RECEIPT DATE: 3-21-16 **ONSITE SEWAGE DISPOSAL SYSTEM** P 558042

PROPERTY ADDRESS: 1890 Florence Road

SUBDIVISION: Chelsea Knolls LOT: Par D TAX ID: _____

CHELSEA KNOLLS, PARCEL D
1890 FLORENCE ROAD, MT. AIRY, MD
TAX MAP 12, GRID 05, PARCEL 78, PLAT#23138
FOURTH ELECTION DISTRICT
HOWARD COUNTY, MARYLAND
SITE PLAN FOR BAT INSTALLATION

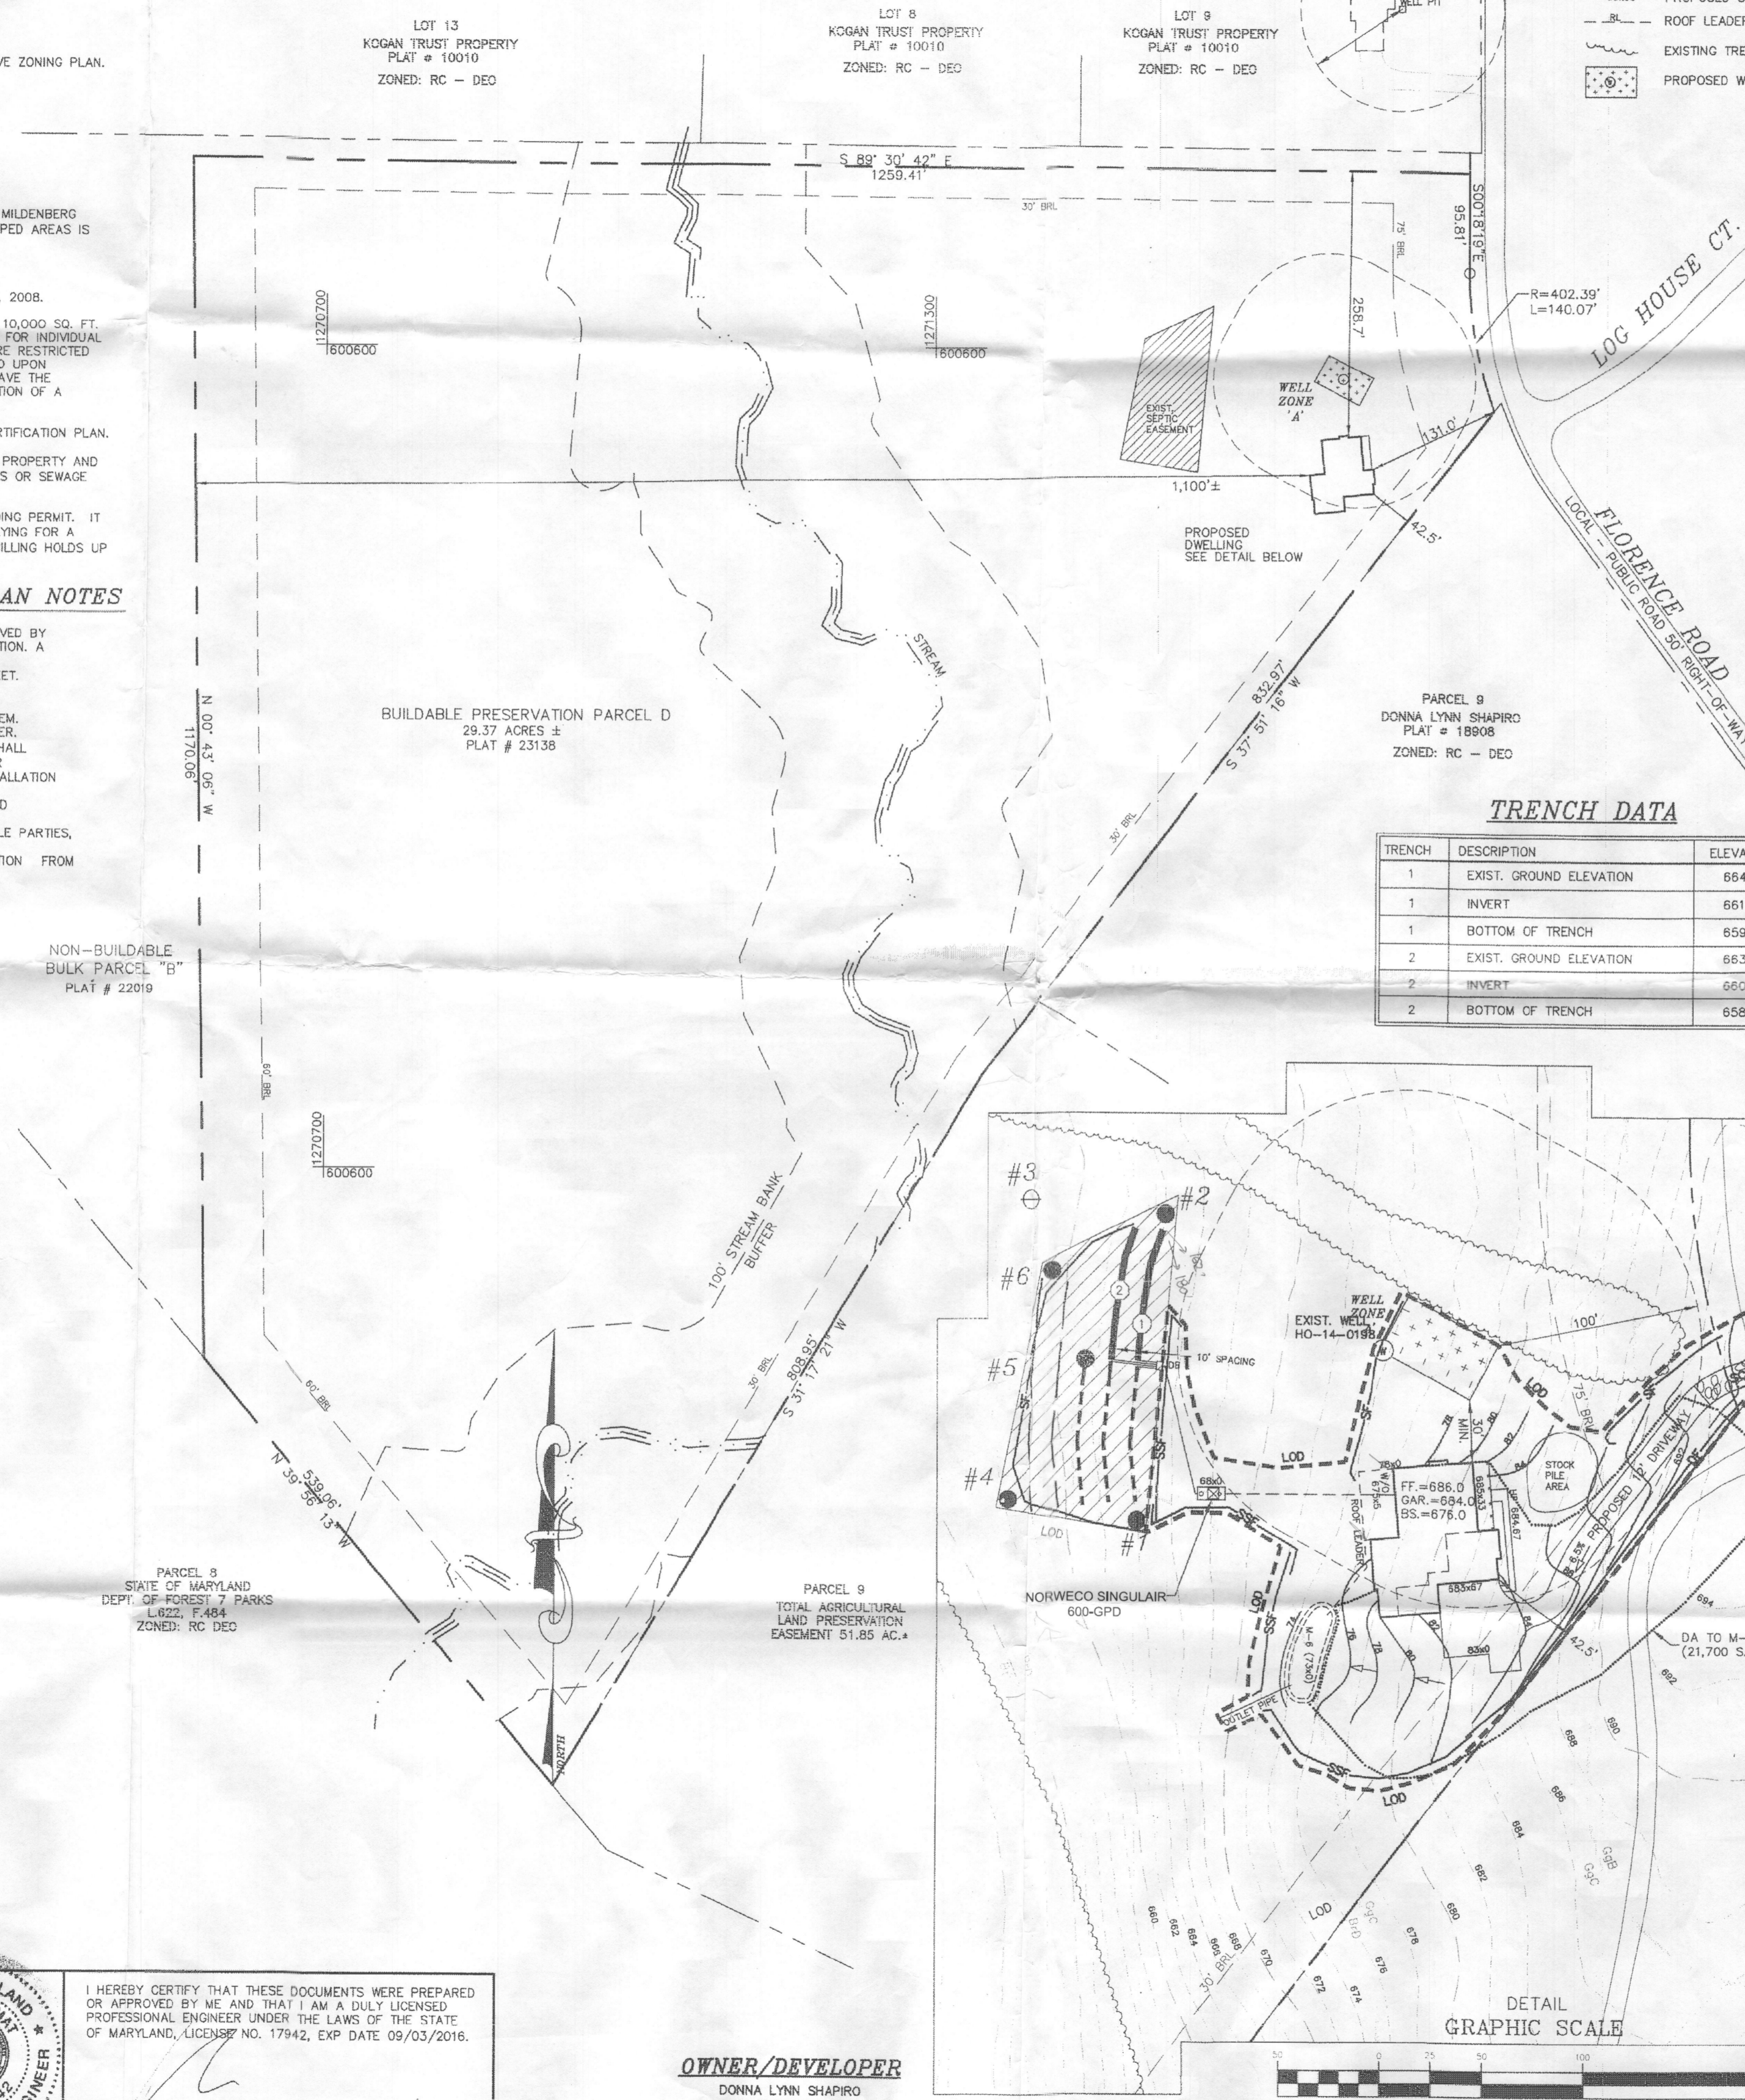
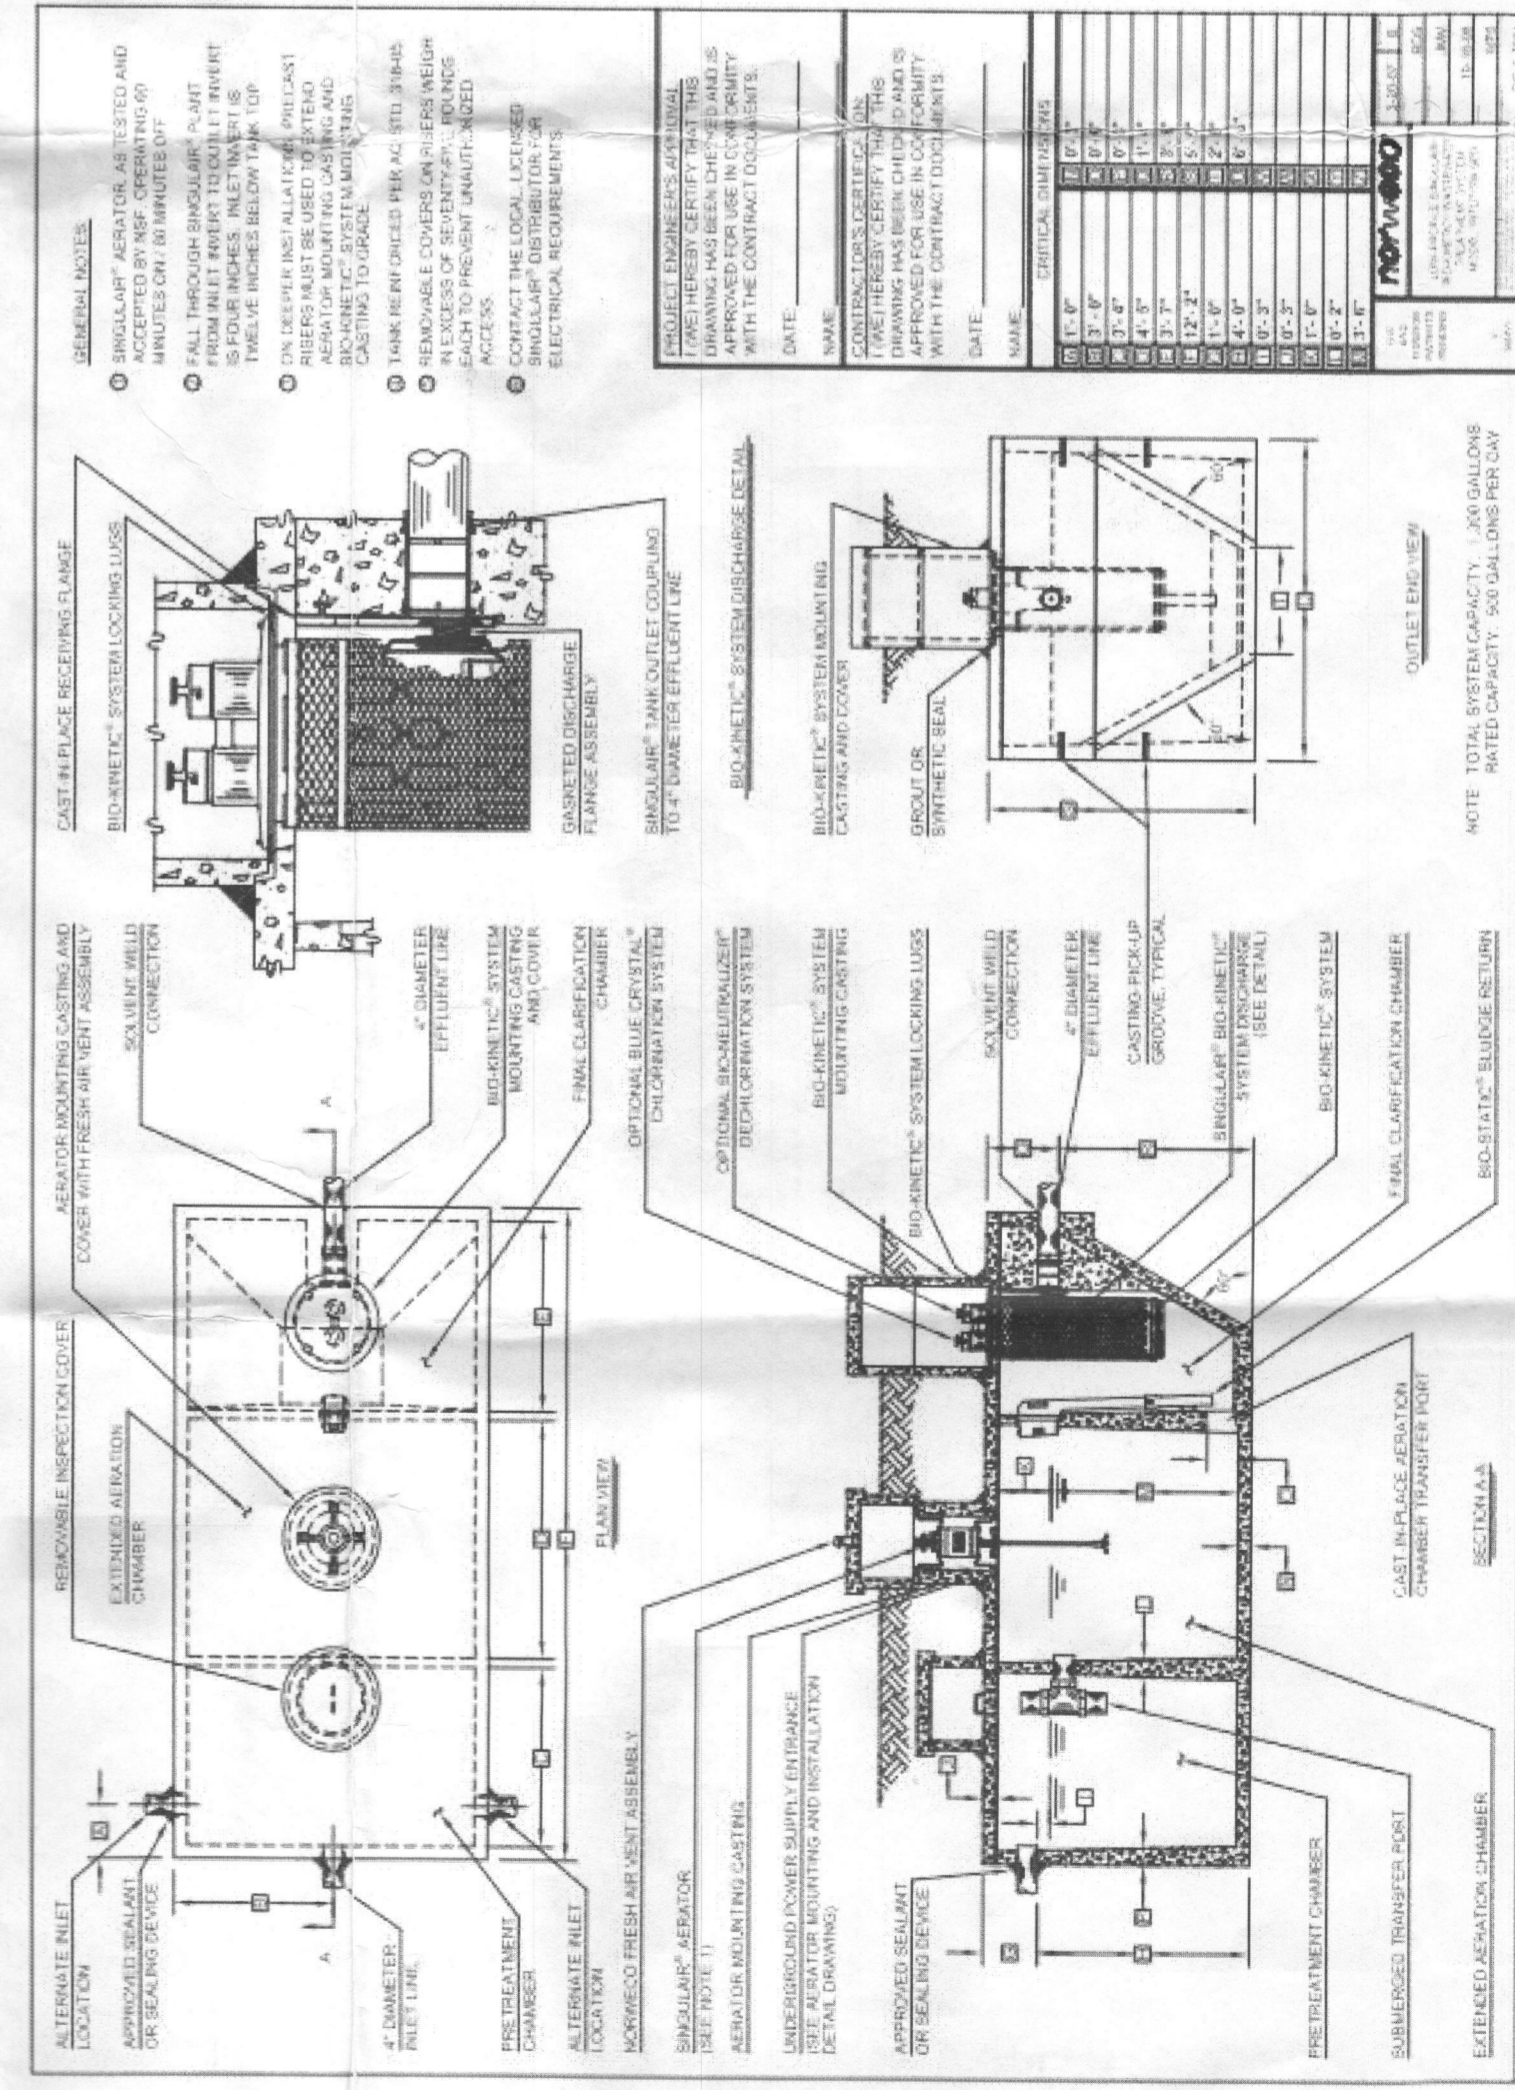
- 1.) Change label on plan to Parcel C (Not D) to match the Perc Cert Plan. Or is it Parcel D in which case the Perc Cert could be "red lined"?
- 2.) Show last 5 feet of sewer line before tank at 2% on sewer profile. Also, I believe the sewer profile scale should be 50 not 30.
- 3.) Show pump runtime on plan = 2 minutes
- 4.) Plot Head Loss on pump curve and designate pump model on plan.

- Revise percolation certification plan to reflect new well box location on BAT Plan.
- Include static head, runtime and dose figures on BAT Plan
- Using the sewage disposal system spec worksheet (attached), change septic design calculations and trench data on BAT Plan
- Change trench spacing to 10 feet on BAT Plan.
- Move trenches closer to holes 2 and 6 on BAT Plan or design a LPD system
